FINAL ENVIRONMENTAL IMPACT REPORT

MERCED UNION HIGH SCHOOL DISTRICT BELLEVUE ROAD AREA HIGH SCHOOL

November 2007

VICINITY MAP

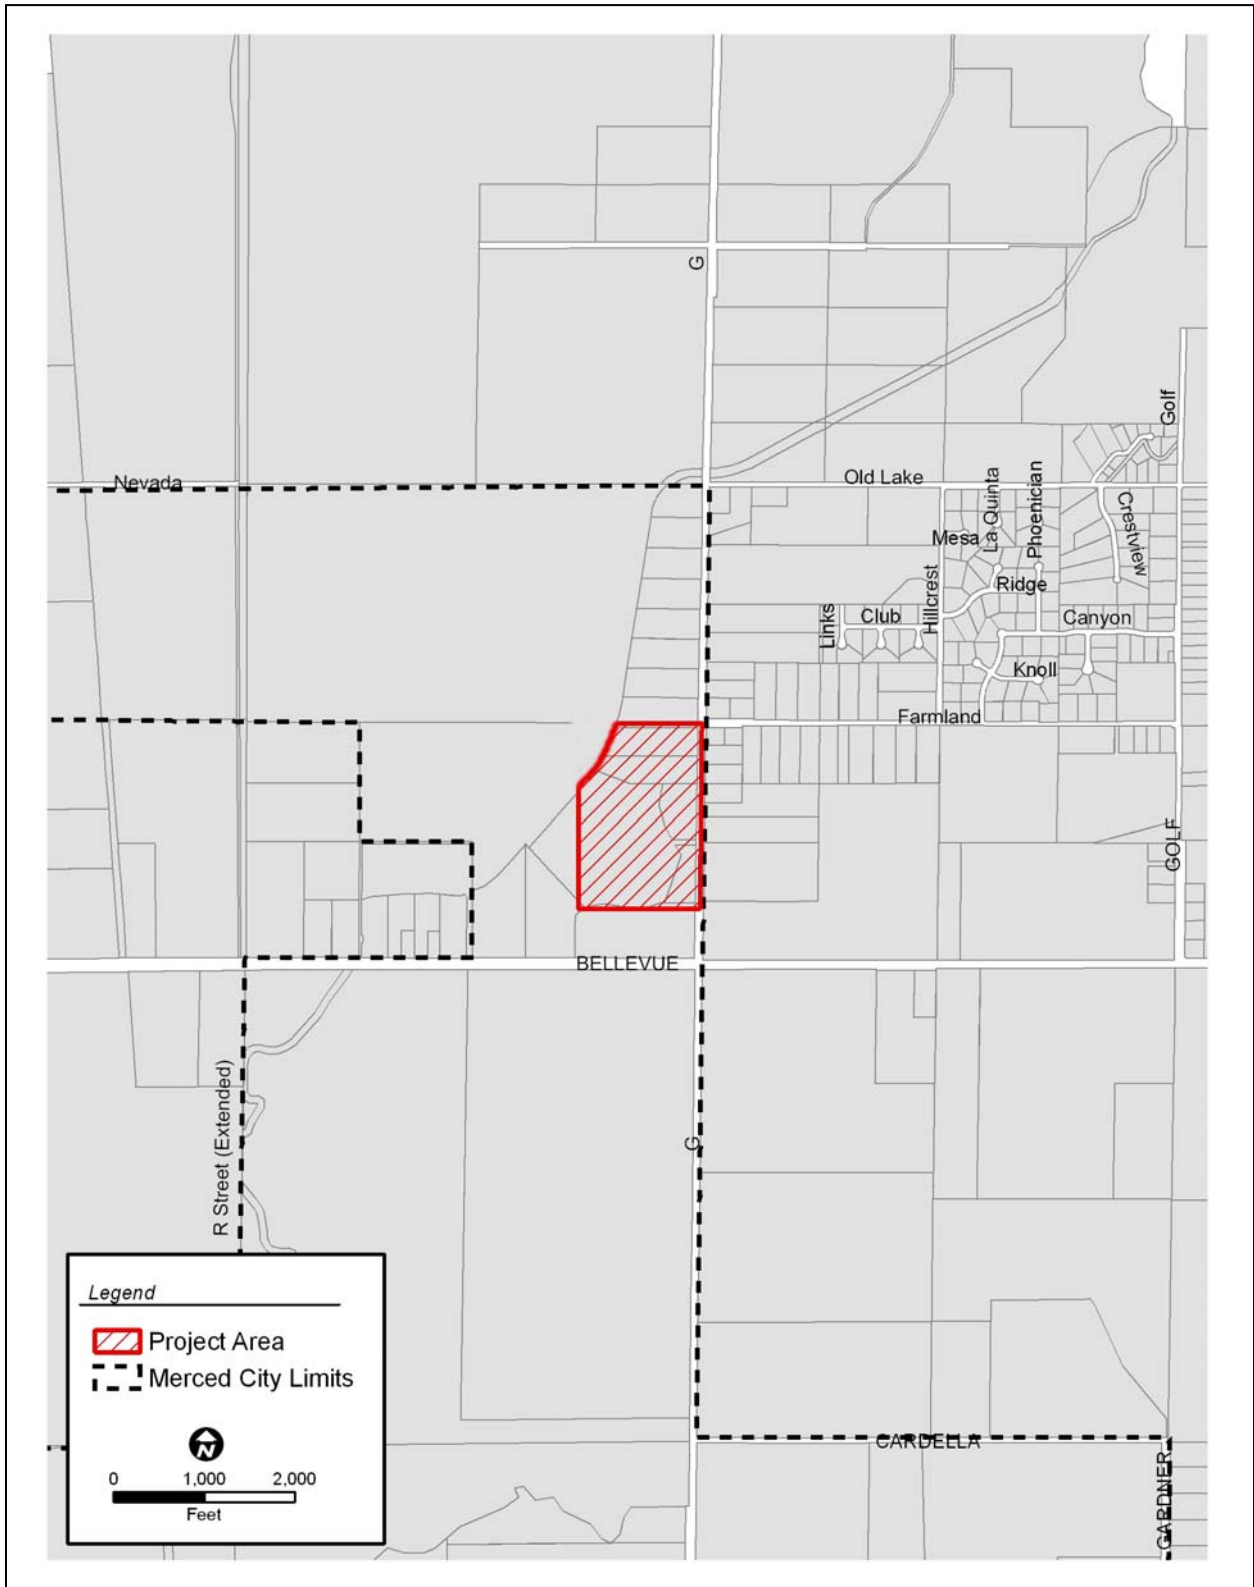
Comment 18: *A clarification of the number of alternatives sites and location of the alternative sites is needed. In the Executive Summary, under “Alternate Site,” it refers to four (4) other sites, but Chapter 4 (Evaluation of Alternatives), page 4-7 limits the EIR analysis to only two (2) sites. Finally, Figures ES-2 and 2-2 shows one (1) alternative site, but this site is not discussed in Chapter 4 and appears to be a mapping error.*

Response: Although the District considered four alternate sites for the proposed project, only two of the sites were evaluated in the DEIR. Figures ES-2 and 2-2 will be revised to remove the reference to the alternate site.
